Subject: Consultation: Alberton Avenue Bus Stop Relocation, Orakei

We are consulting with you regarding a proposal to relocate the bus stops between No.s 75 and 63 Alberton Avenue, in Orakei.

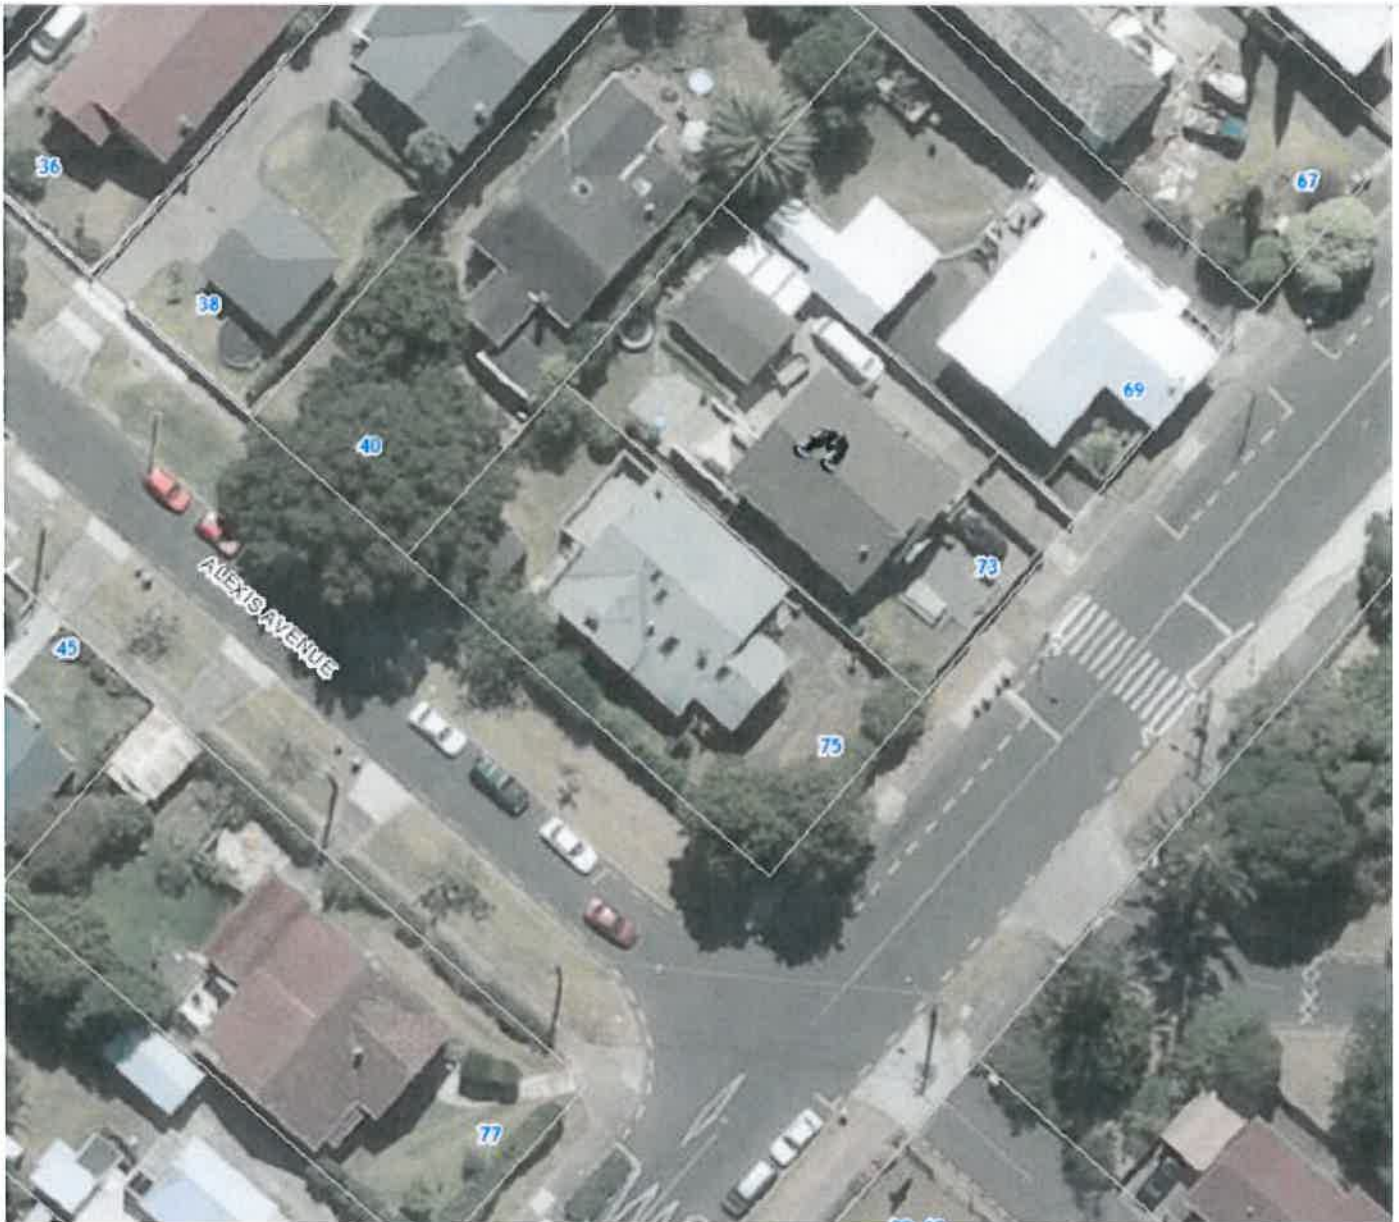
We are currently investigating safety of the zebra crossing outside Mt Albert Grammar School and it appears that the resident may be using the existing pram crossing as a vehicle crossing. As shown in the attached photo there is formal driveway adjacent to the crossing and there is also a car parked behind the wooden gate. Looking at the

aerial it appears that a vehicles will need to drive partially / completely over the current pram crossing in order to park inside the wooden gate. However I haven't seen any cars actually doing so when I was on site.

I was wondering if you can assist on this. Currently we are the bus stops and zebra crossing outside Mt Albert Grammar School on Alberton Avenue and I suspect that the resident may be using the pram crossing as a driveway to park into [REDACTED]. There is already a driveway going into the property but there is also a wooden fence in line with the rock wall with a car parking inside. Please see attached.

Do you think there will be any records showing the actual location of the vehicle crossing in the consent?

There is no vehicle crossing permits for this property. It seems that this gate is there for long time based on aerial photos.
